Dansk Data Elektronik A/S

**Technical
Field Change Notes**

Updated 15th June 1994

SUPERMAX FIELD CHANGE NOTICE NO. 26

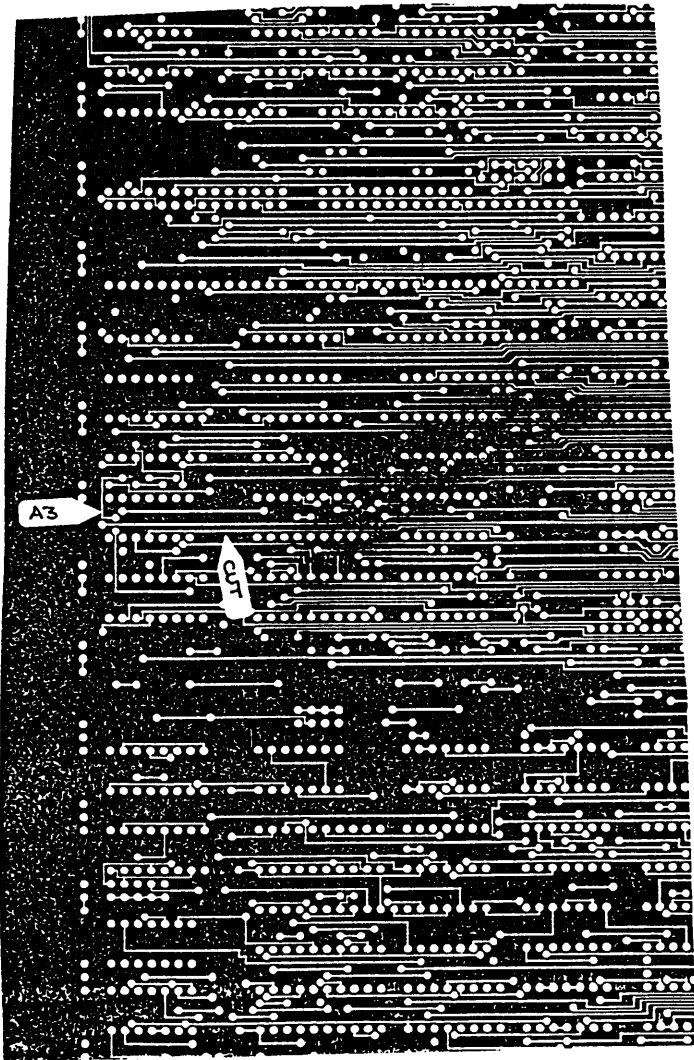
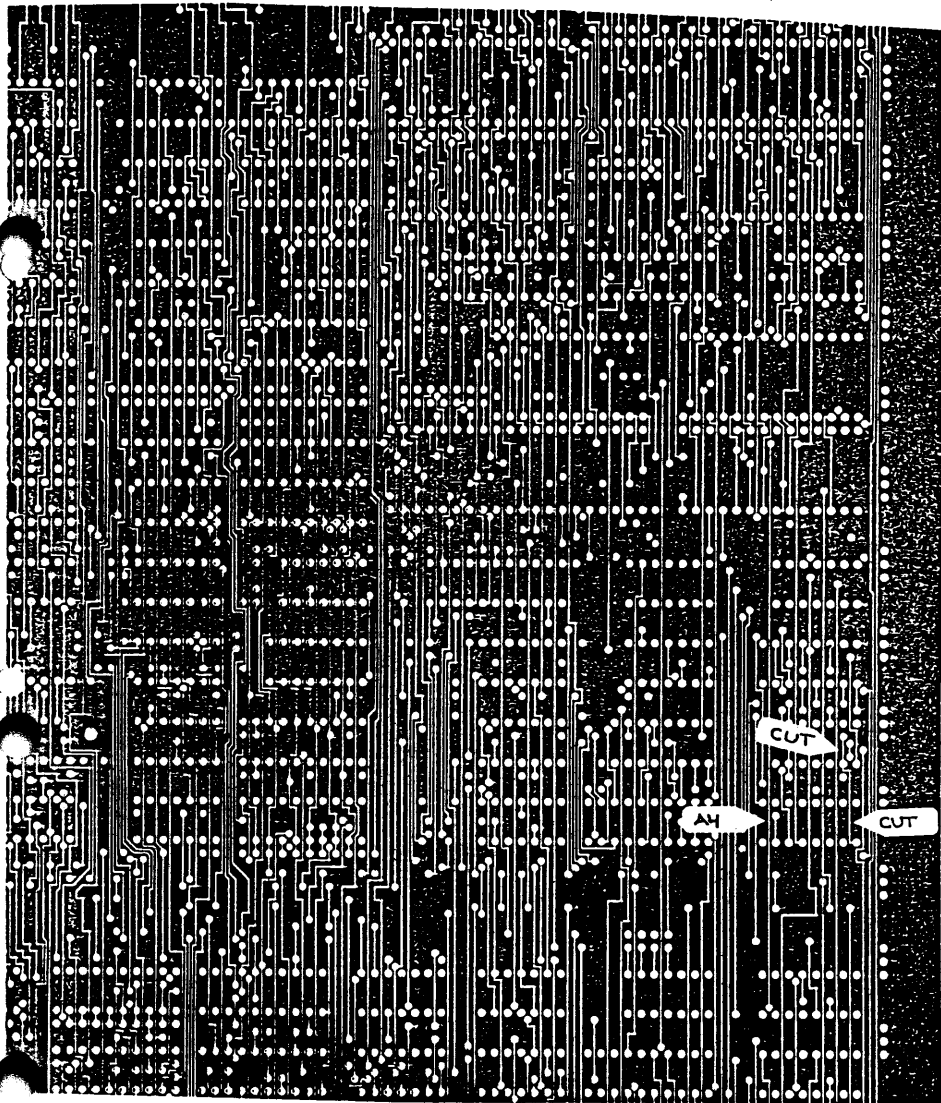
1. Update board to revision level D. (Field change note 22)
2. Check with ohm-meter the connection between A2 pin 11 and M9 pin 08.
3. Disconnect A2 pin 11 by cutting wire on component side. See page 3.
4. Check no-connection between A2 pin 11 and M9 pin 08.
5. Check with ohm-meter the connection between A3 pin 04 and F2 pin 01.
6. Disconnect A3 pin 04 by cutting wire on component side. See page 4.
7. Check no-connection between A3 pin 04 and F2 pin 01.
8. Check with ohm-meter the connection between A3 pin 02 and A4 pin 01.
9. Disconnect A3 pin 02 by cutting wire on solder side. See page 5.
10. Check no-connection between A3 pin 02 and A4 pin 01.

11. Check with ohm-meter the connection between A3 pin 02 and the plated through hole near the pin on the solder side. See page 5.
12. Disconnect A3 pin 02 by cutting wire on solder side. See page 5.
13. Check no-connection between A3 pin 02 and the plated through hole near the pin.
14. Connect A2 pin 11 to F2 pin 01 with insulated wire on the component side.
15. Connect A3 pin 02 to O2 pin 15 with insulated wire on the component side.
16. Connect A3 pin 04 to O1 pin 13 with insulated wire on the component side.
17. Connect A4 pin 01 to the plated through hole near A3 pin 02 with insulated wire on the solder side.
18. Change PAL package T2 from CC10 to CC11.
19. Change revision level from D to E by removing the letter D in the PCB identification on the component side of the board.

CPU 4501, ISS 1. Solder side.

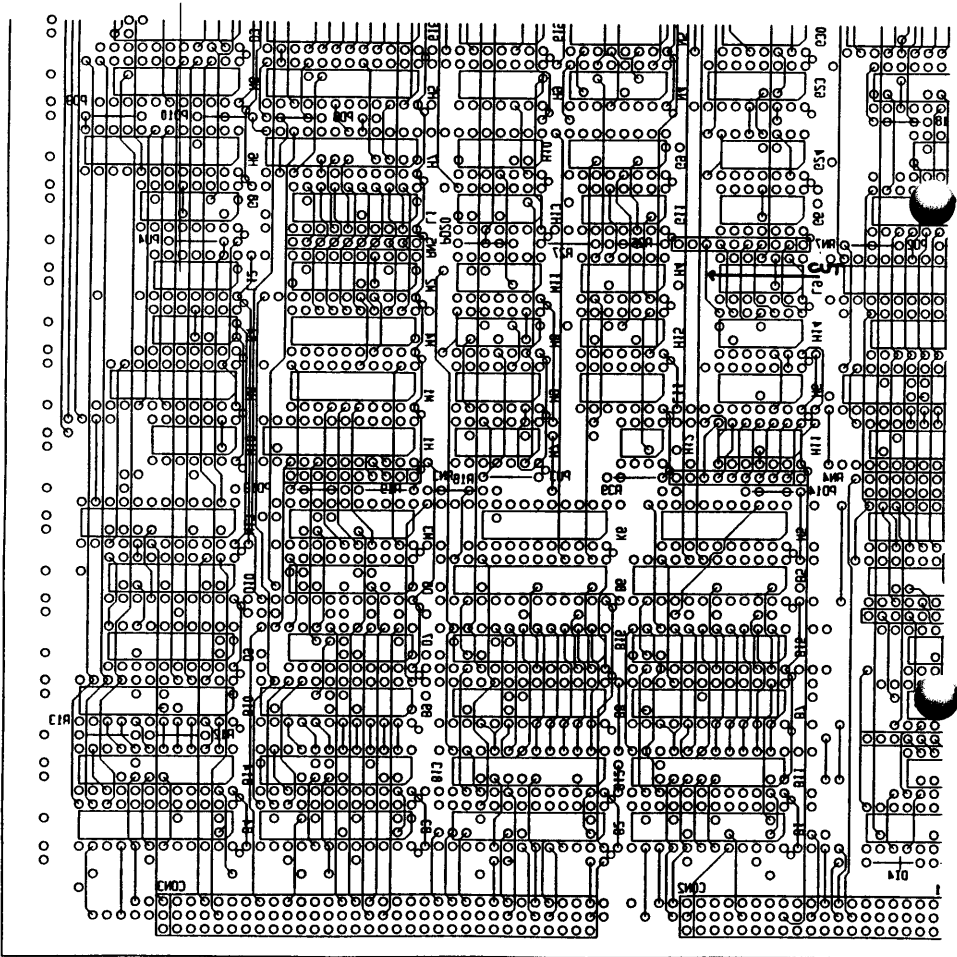
Circuits involved:

Name	Type	Position
RN7	SIL	H6
H14	SWITCH	H5

Board layout details DIOC4000.

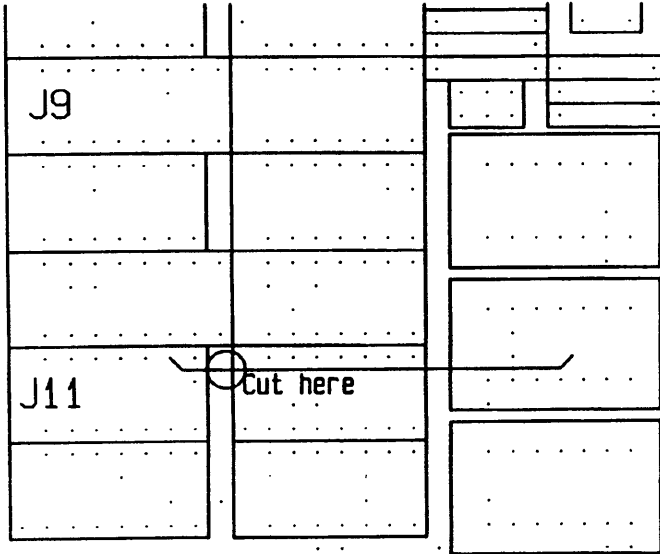
1. Cut the connection between J8 pin 5 and J11 pin 9 on the component side of the PCB. (See the drawing on page 2, regarding the location of that connection.)
2. Connect J9 pin 6 and J11 pin 9 using insulated wire on the component side of the PCB.
3. Update the PCB revision field:
 - DIOC4000 ISS 1: Update to revision K by removing the letter J in the PCB revision field label.
 - DIOC4000 ISS 2: Update to revision G by removing the letter F in the PCB revision field.

SUPERMAX FIELD CHANGE NOTICE NO. 27

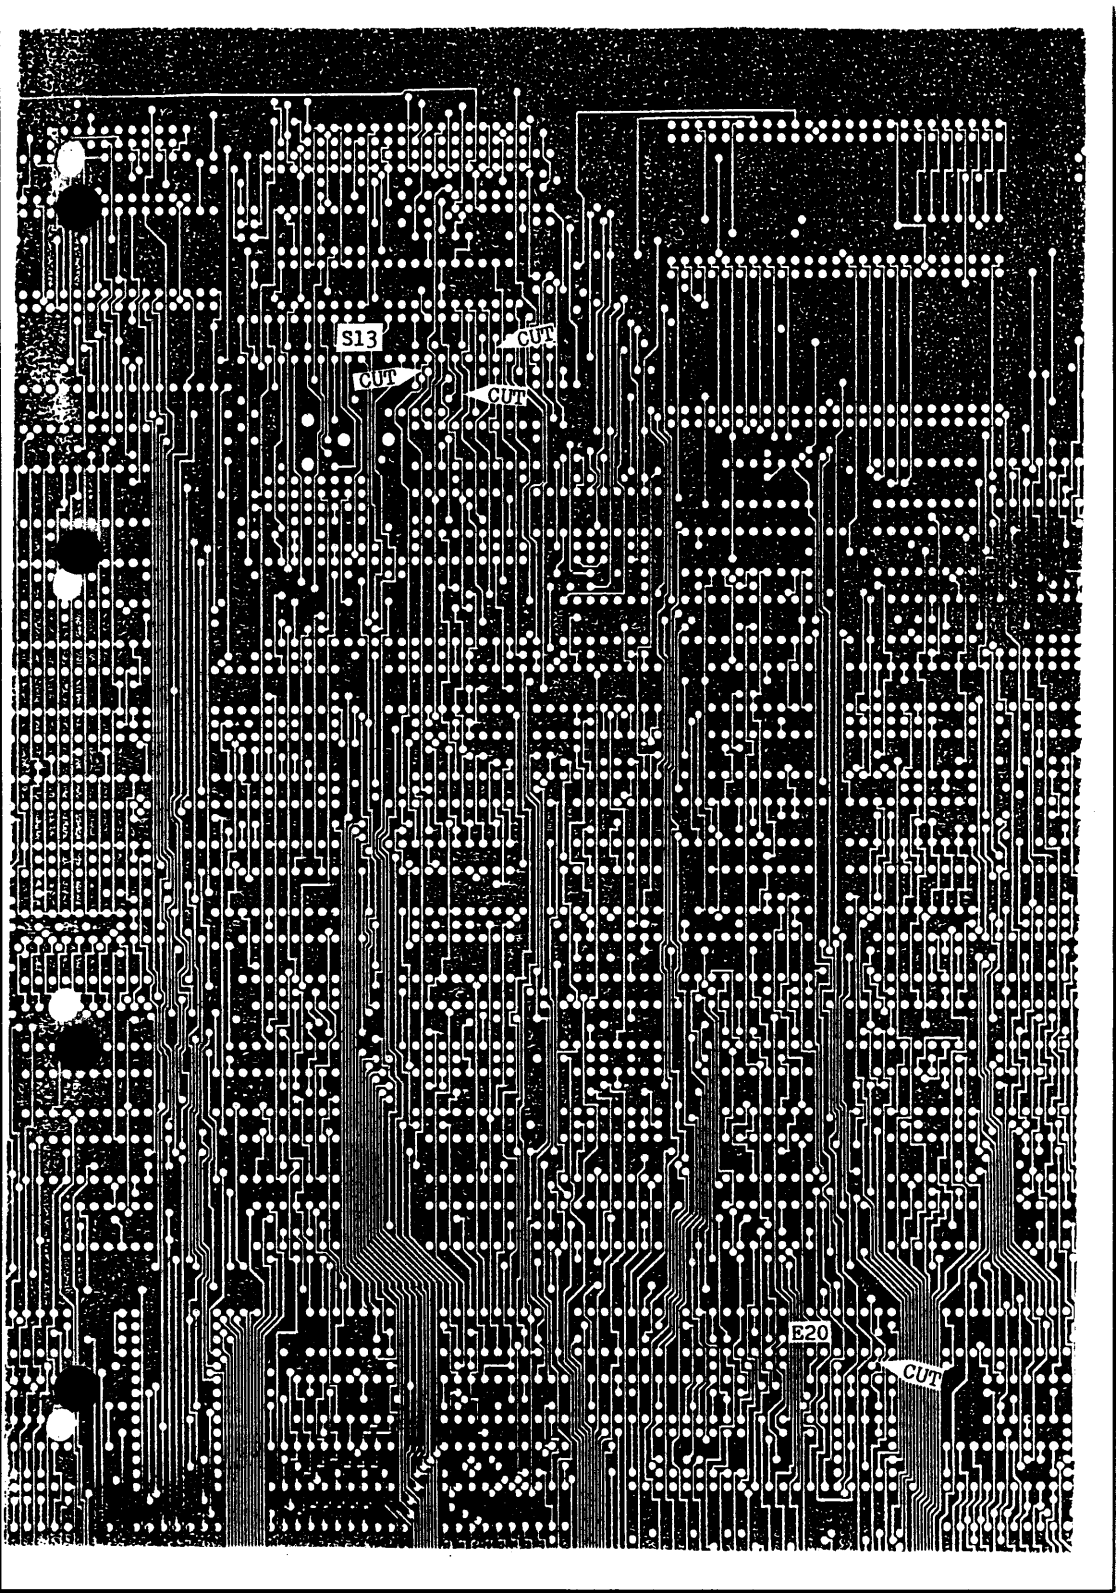
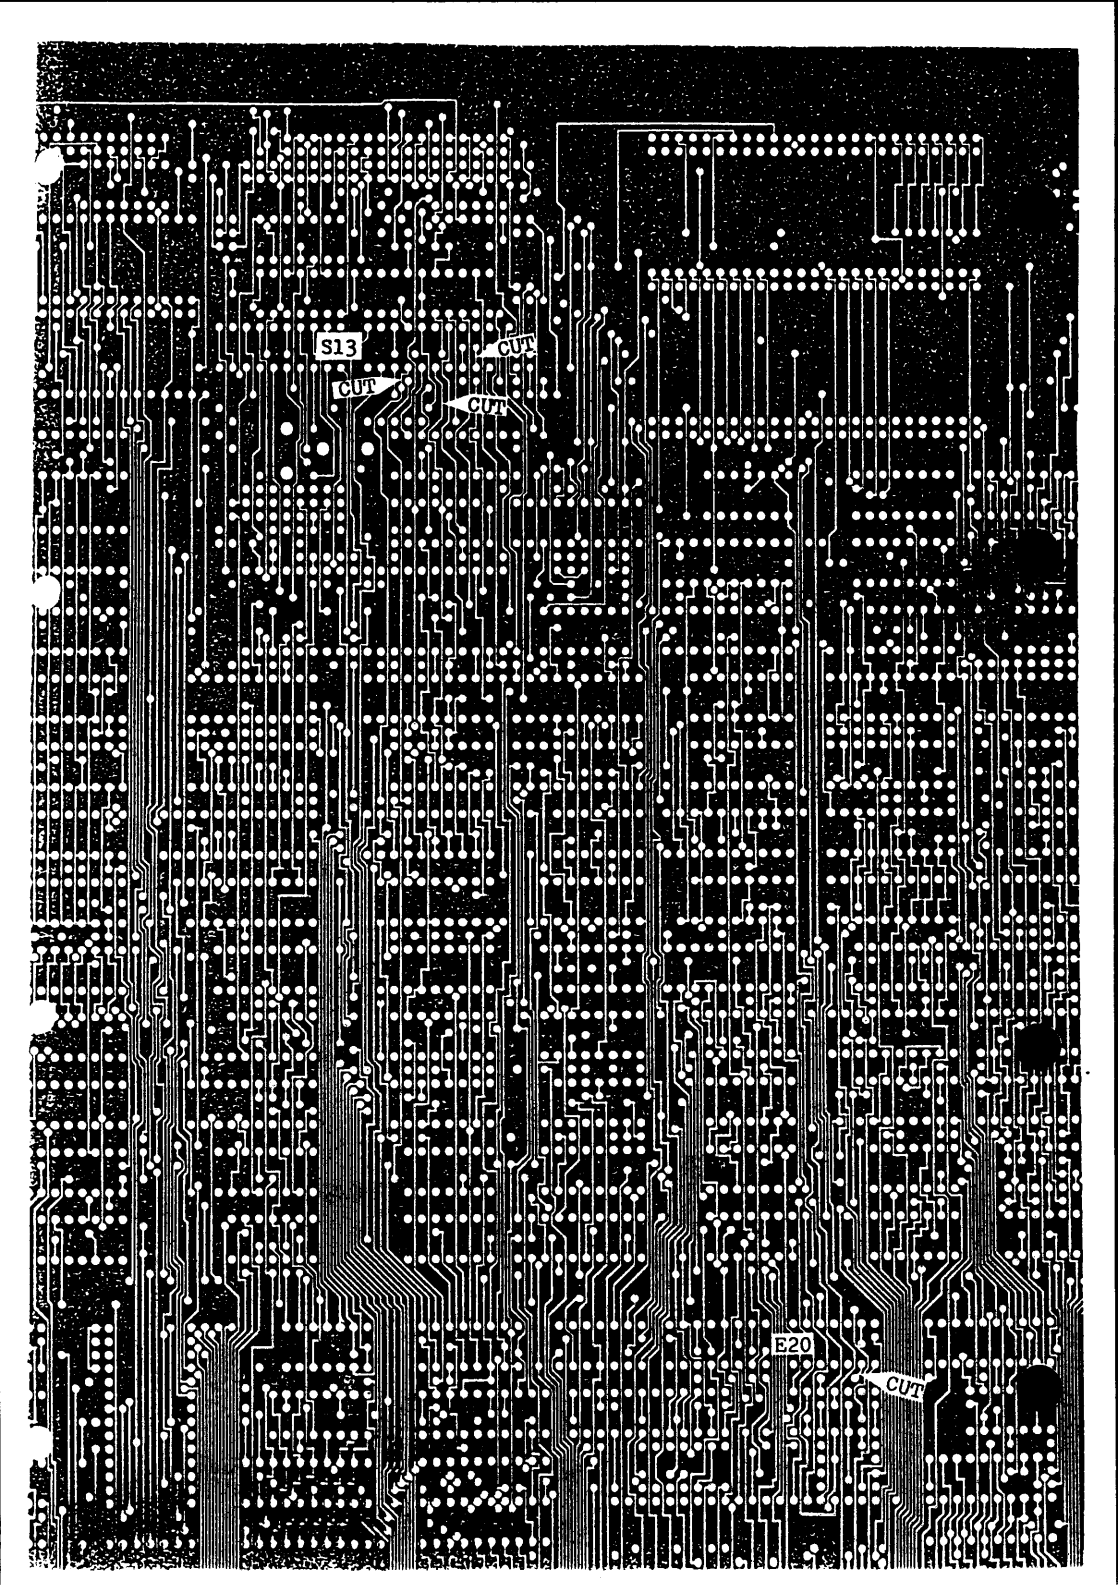
CIRCUITS INVOLVED:

Name	Type	Position
S13	PAL D2P60	B 13,5.
D2	2681	B 13,2.
S3	74LS273	B 11,7.
S10	74S74	B 11,5.
S18	74S74	B 12,7.
E20	74S00	A 11,8.
G6	74S04	B 1,3.

SUPERMAX FIELD CHANGE NOTICE NO. 25

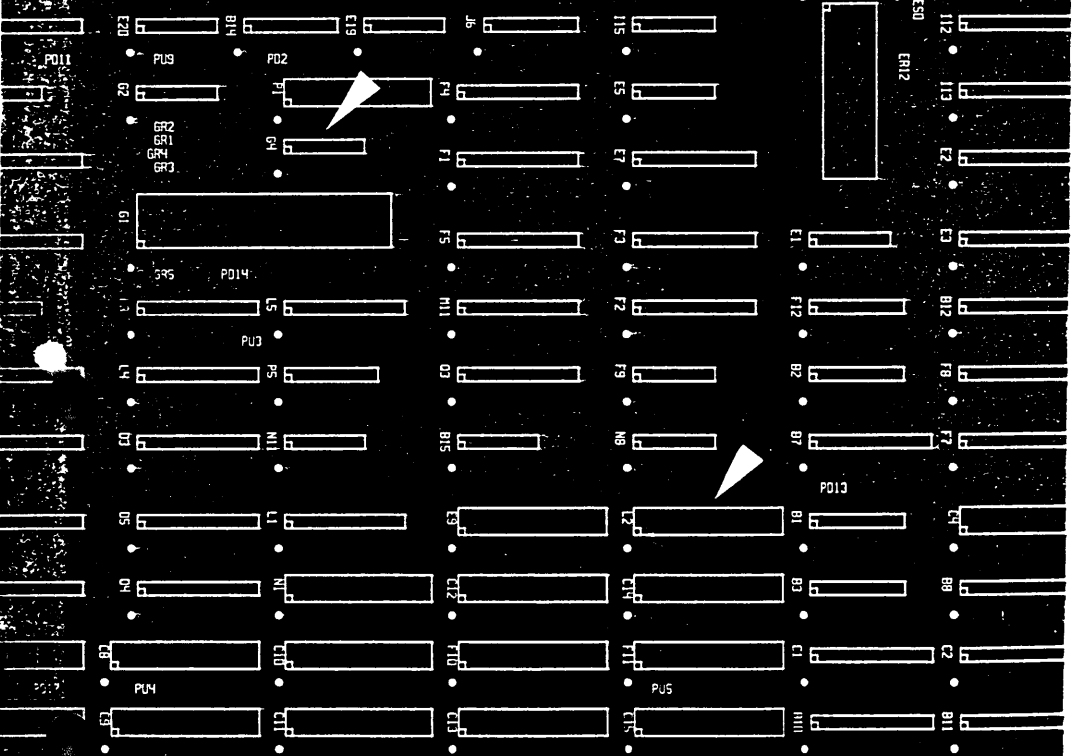
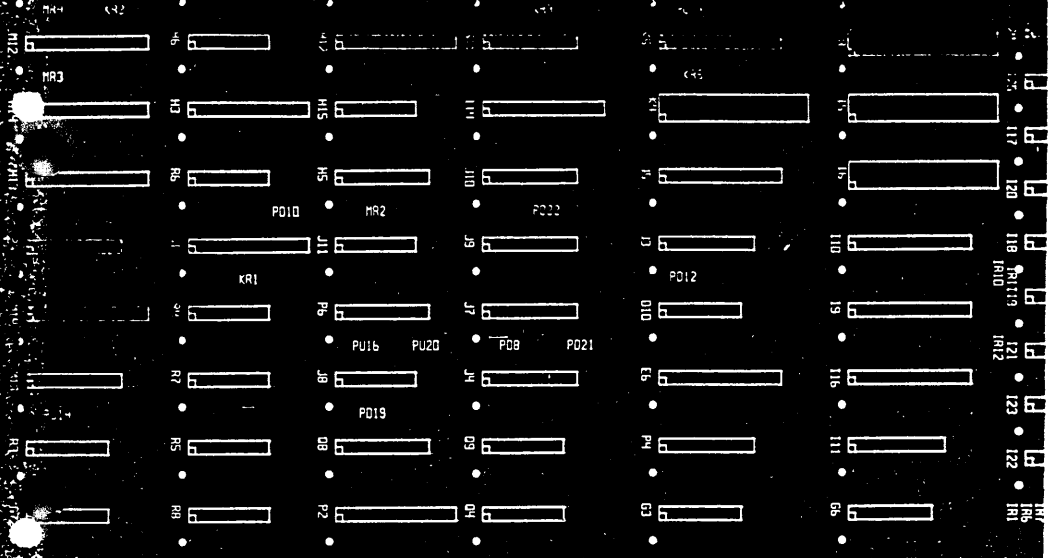
Package H10 is 74S74, position B 12,7.

Connect 1k ohm resistor between H10 pin 14 and H10 pin 10 on solder side of the board.

Supermax Field Change Notice no. 94

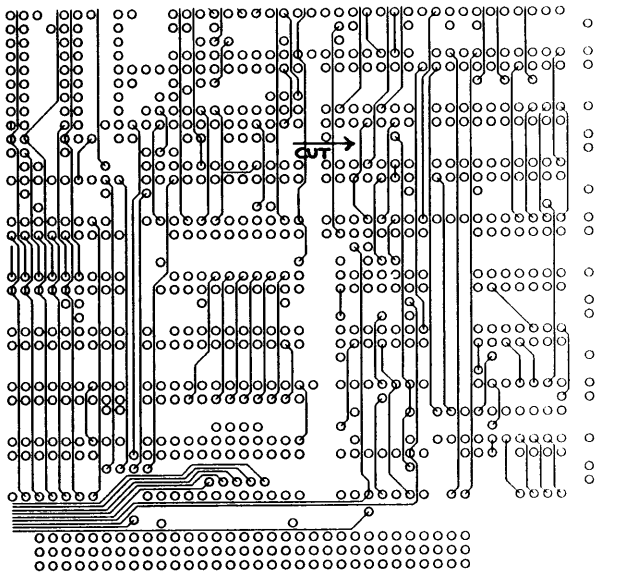
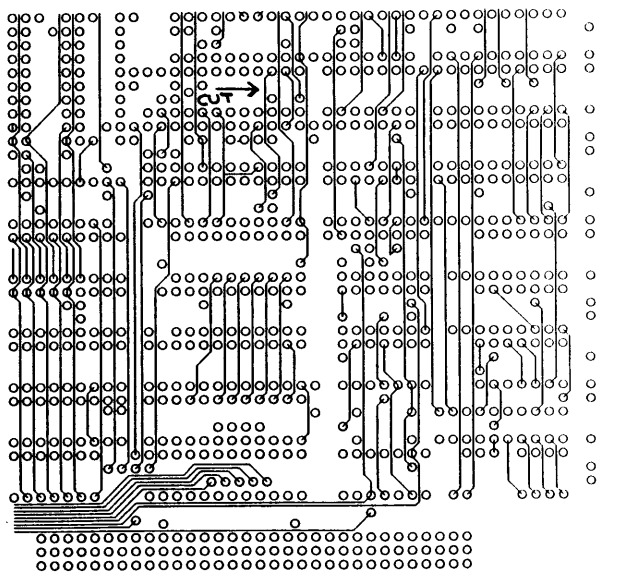
1. Cut the PCB wire on the solder side of the PCB. See the attached page.
2. Connect P5 pin 11 to O6 pin 10 with insulated wire on the component side of the PCB.
3. Change PAL L1 to D3162.
4. Update PCB revision field:
 - 4000 ISS 1: Update to revision H by removing the letter G in the PCB identification field.
 - 4000 ISS 2: Update to revision E by removing the letter D in the PCB identification field.
